Equipment Environmental Qualification Review

Responses to

Draft Interim Technical Evaluation Report

Zion Station - Units 1 & 2

ELECTRICAL PENETRATOR ASSY TYPE 3.143.1A, 600 VOLT CONTROL SERVICE (NORMAL DUTY PLUS 10% OF COND POST-ACCIDENT DUTY)

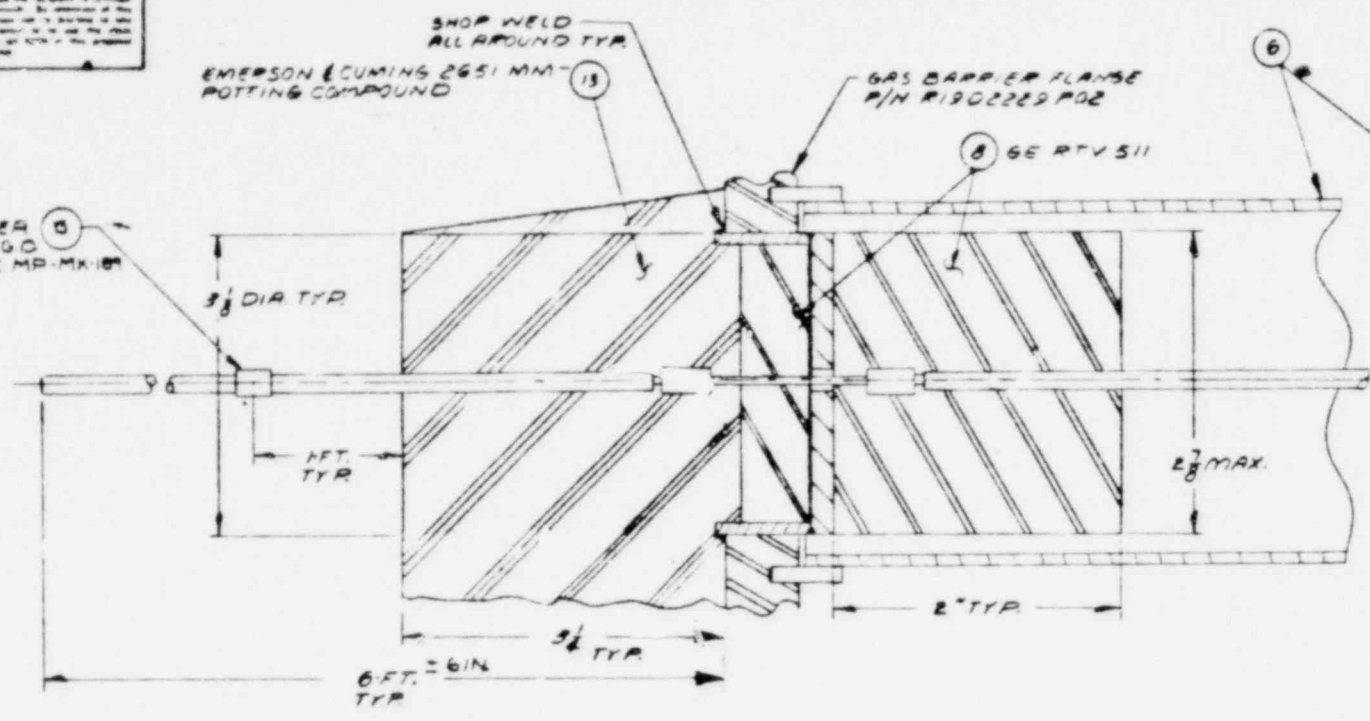
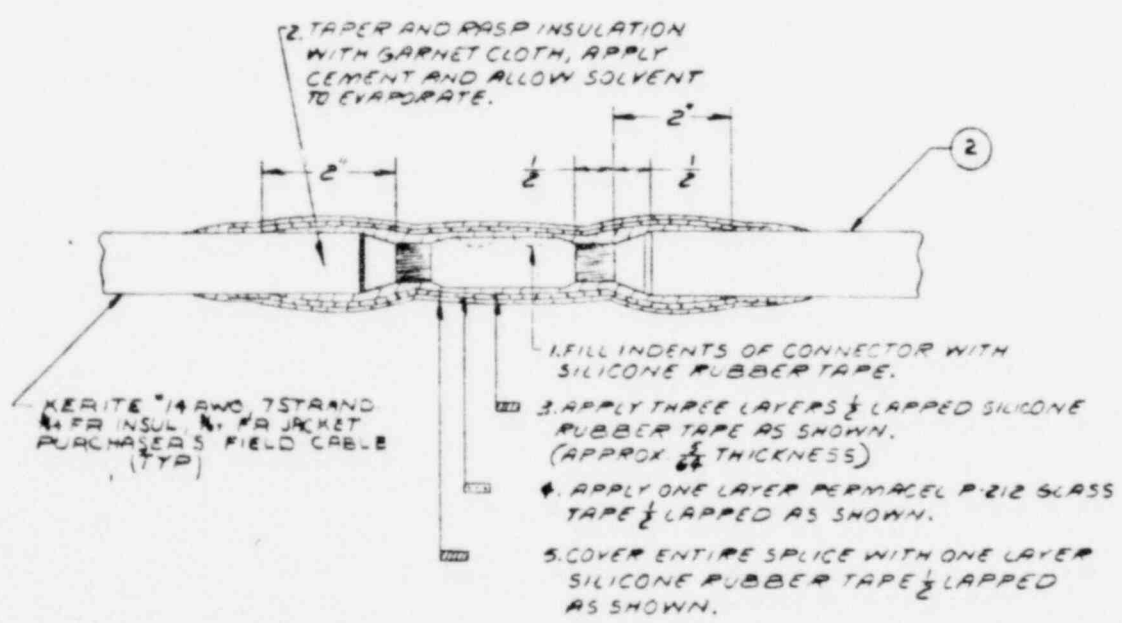
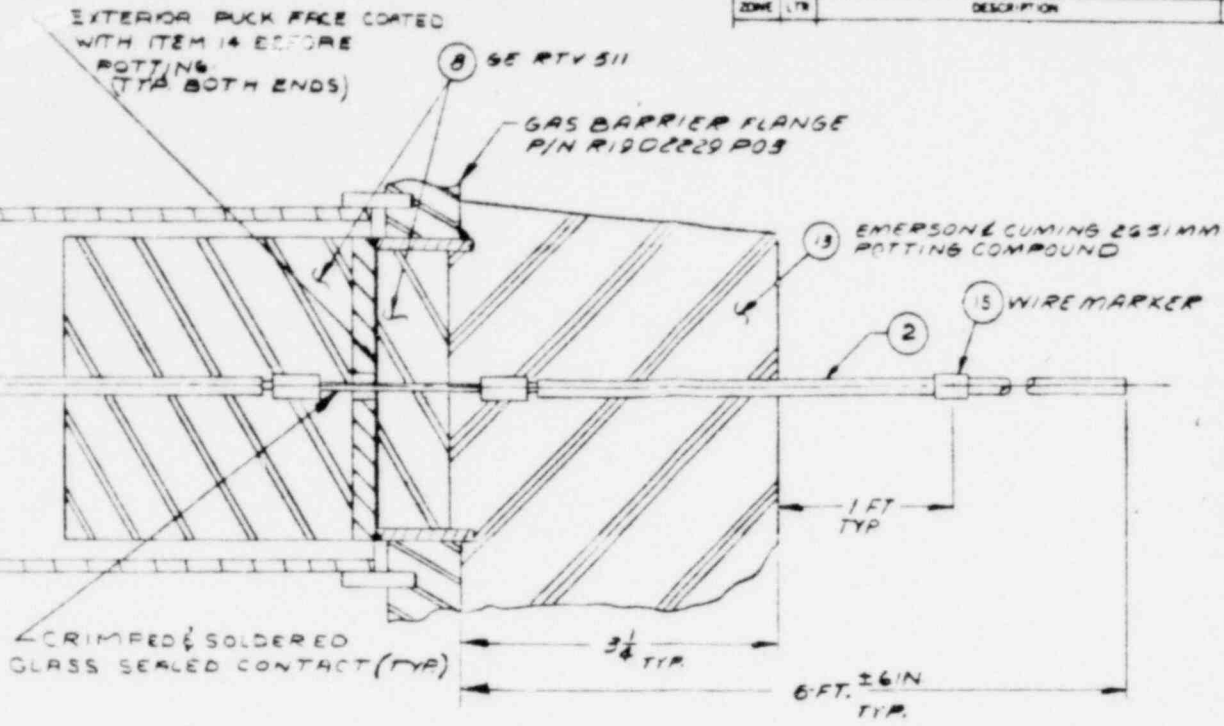
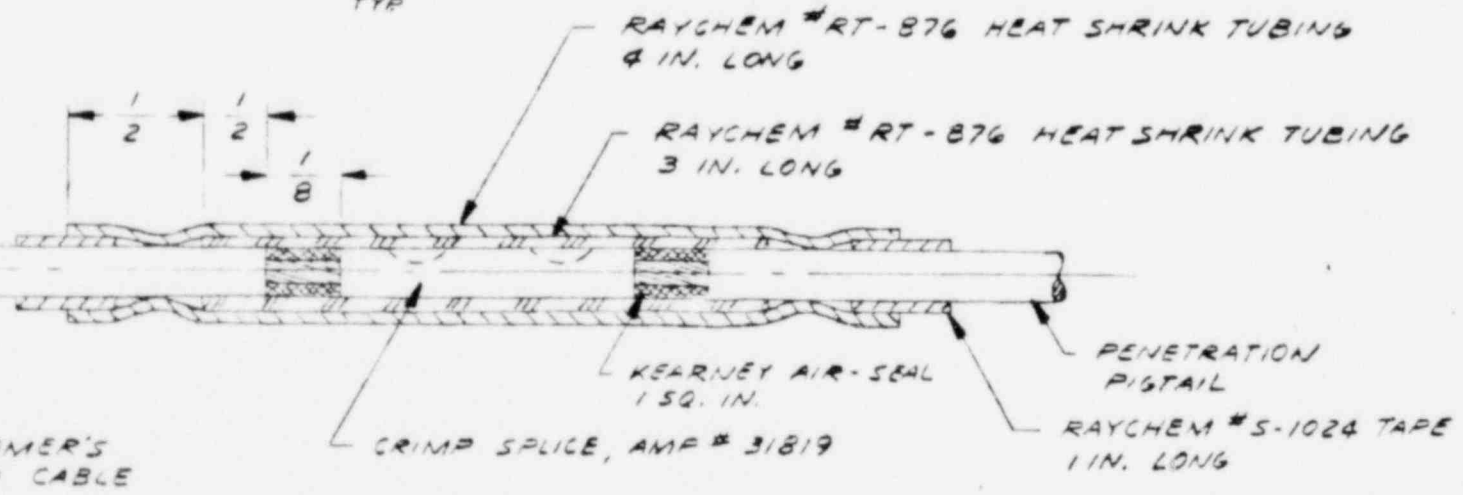
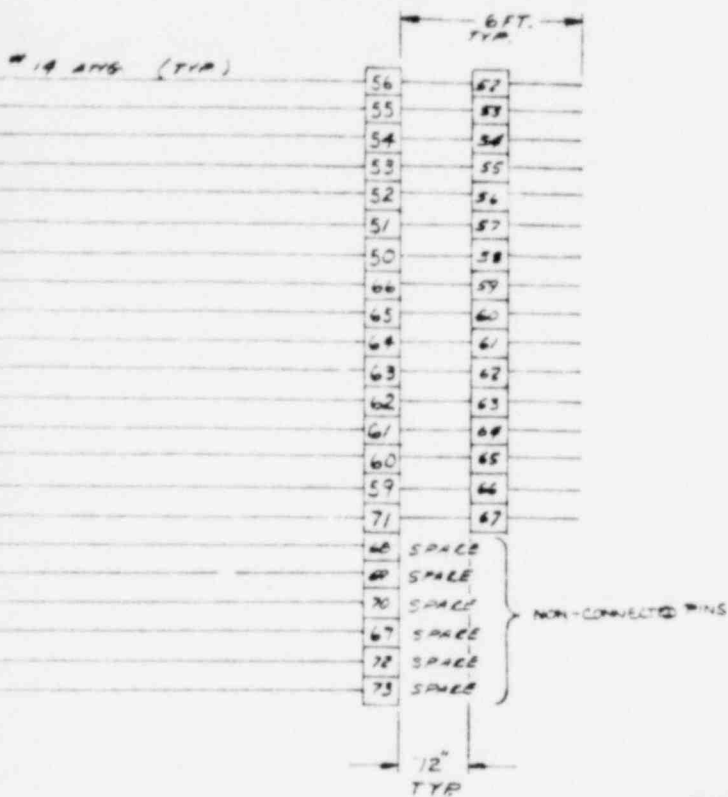
1. The splice kits (Kerite Splice Kit DS-1001) used for 600 Volt Control Service are shown on D. G. O'Brien Drawing R19D2226G, Sheet 2, Revision F (see attachment to our response to TER Item 3.3.2.8).

DATE		SERVICE WATER PUMP 16	
8-26-71	8-1-71	SCHEMATIC DIAGRAM ZION STATION UNIT 1 COMMONWEALTH EDISON CO CHICAGO ILLINOIS	
SARGENT & LUNDY		JOB NO. 3782	DWG. NO. 22E-4860
3-29-71		PAGE	SW 3

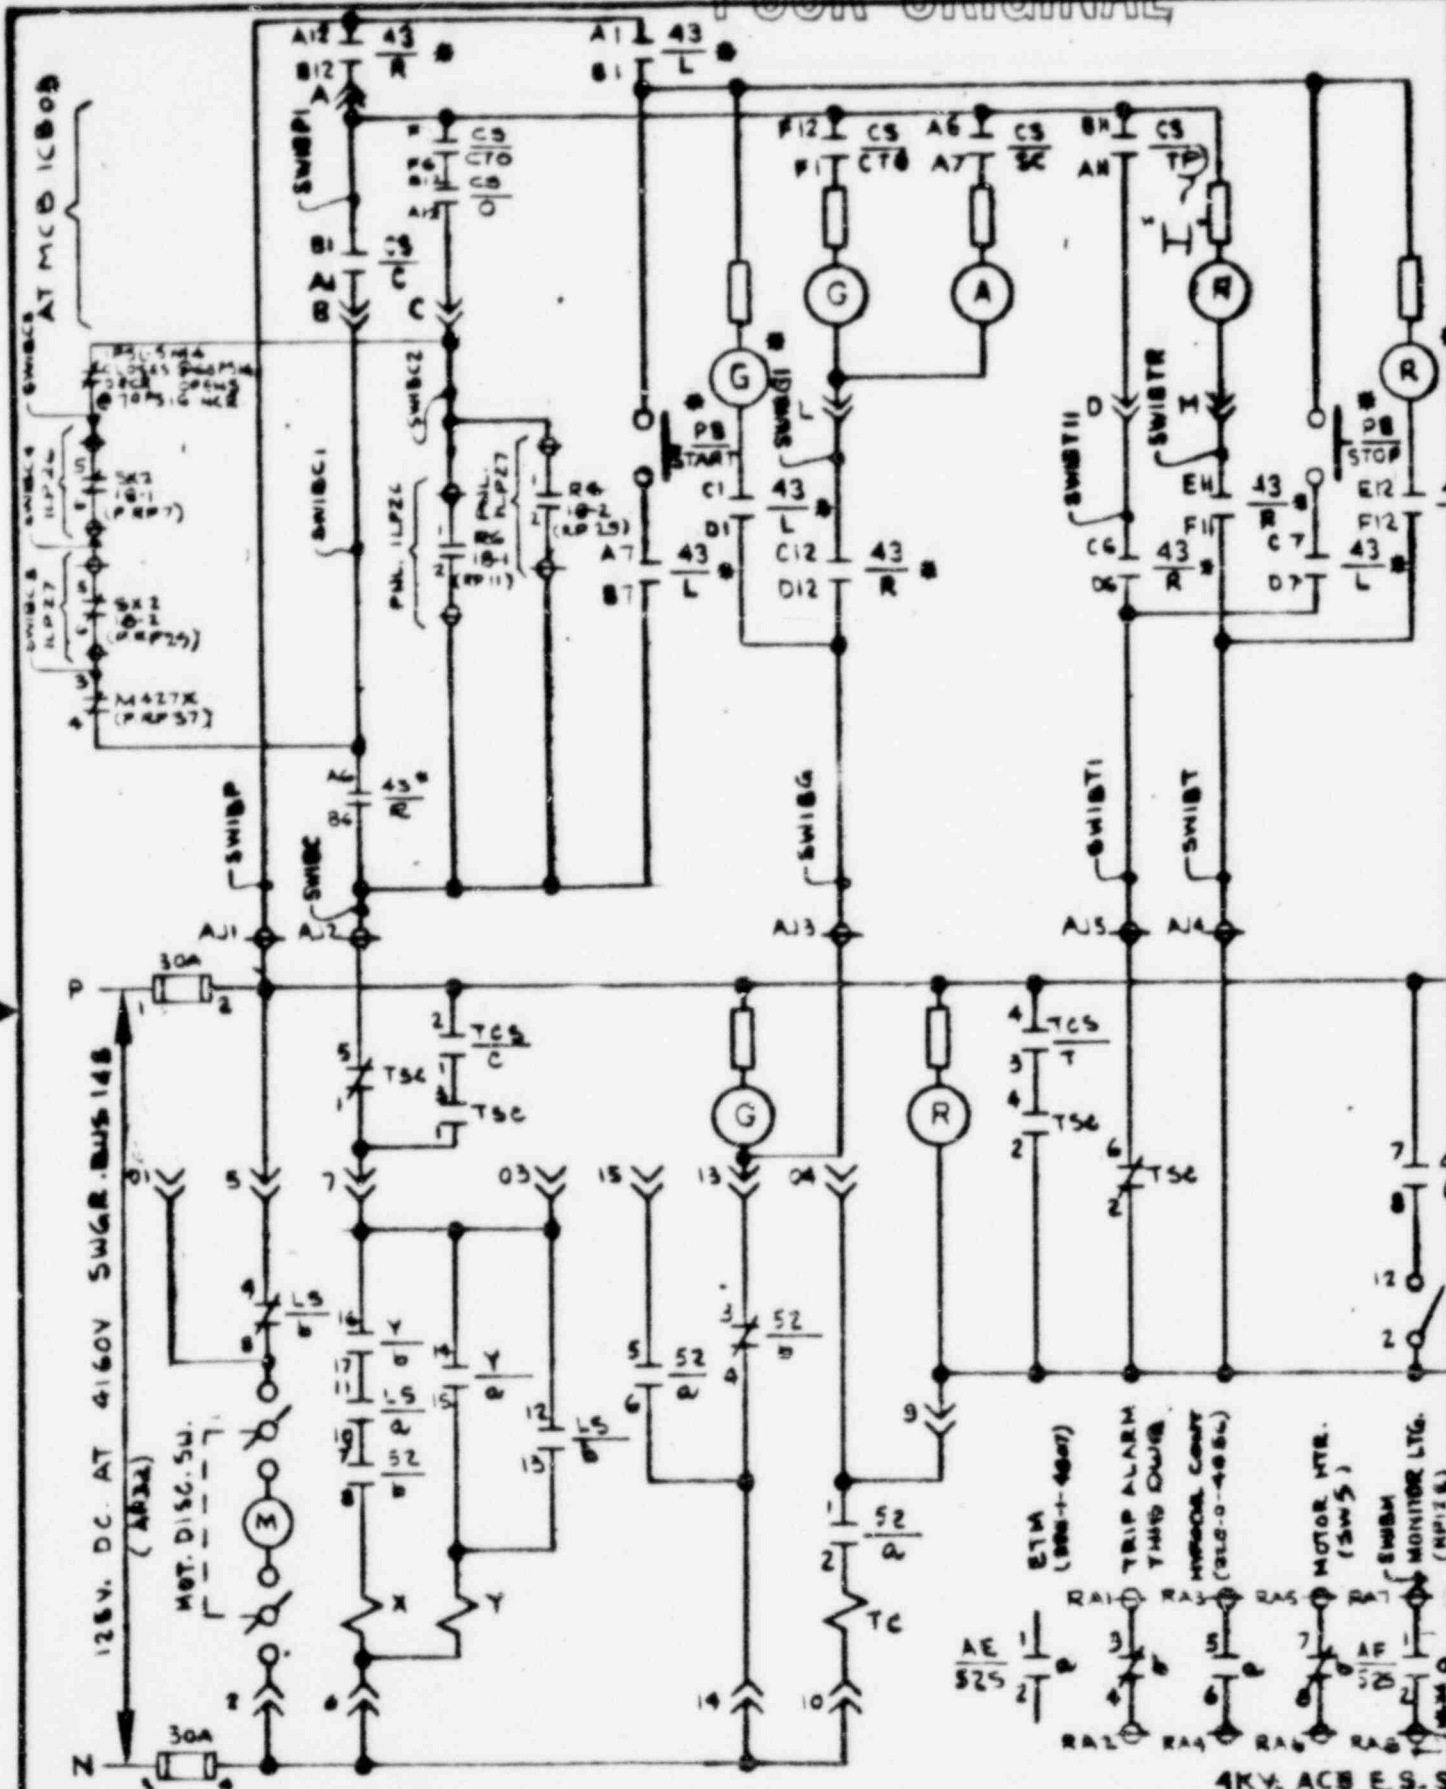
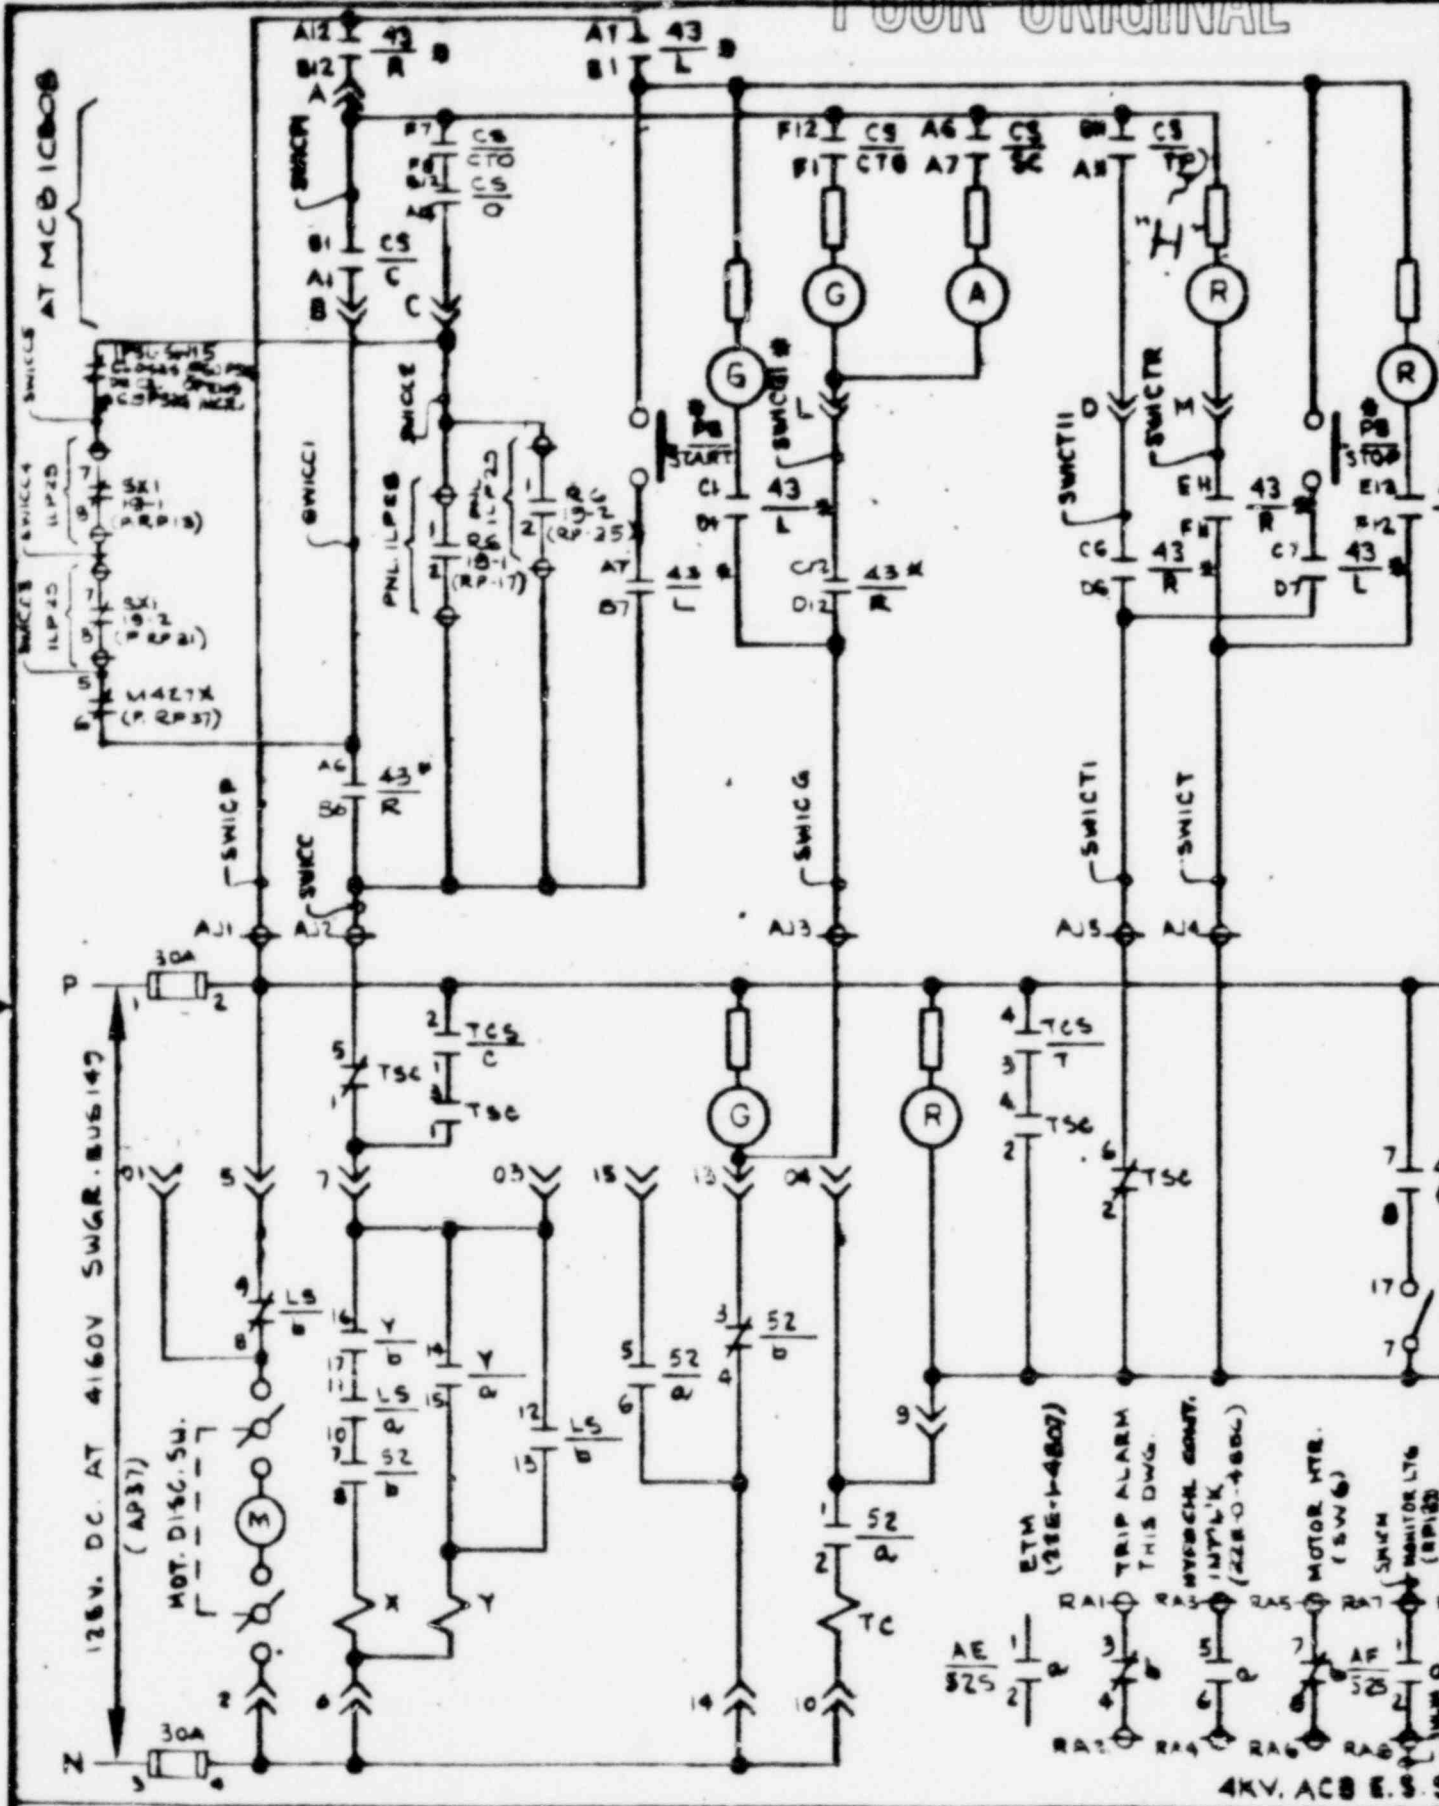
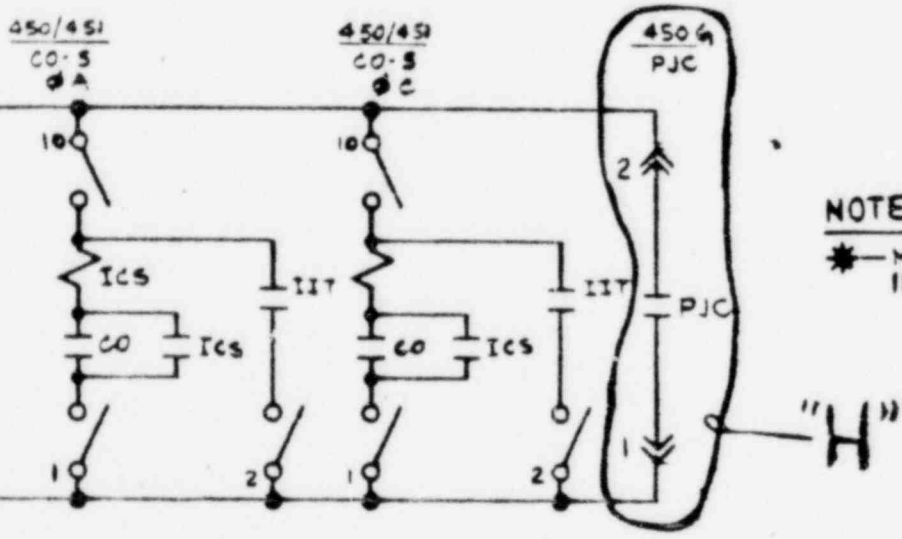
The control circuit for the service water pump 1A is shown on Drawing 22E-1-4840, Page SW1 (attached). The control circuit for service water pumps 1B and 1C are shown on Drawing 22E-1-4840, Pages SW2 and SW3 respectively. Since the control circuit is identical for pumps 1A, 1B and 1C (likewise for Unit 2) the following analysis is equally applicable to all service water pumps.

For the failure mode of the contacts failing to close, the service water pump would remain in its standby state of readiness and would be started by the automatic safety actuation circuits.

For the failure mode of the pressure switch contacts shorting to ground, an alarm would be sounded (in the control room) indicating a ground on the normally ungrounded 125V DC system. No control action of the service water pump would be affected since both polarities of the 125V dc control circuit are ungrounded, and the fuses will not "blow" until a second ground occurs in the opposite polarity. Zion Procedure ("DC Ground Location Procedure") calls for locating and removing all grounds on the DC systems as soon as detected.
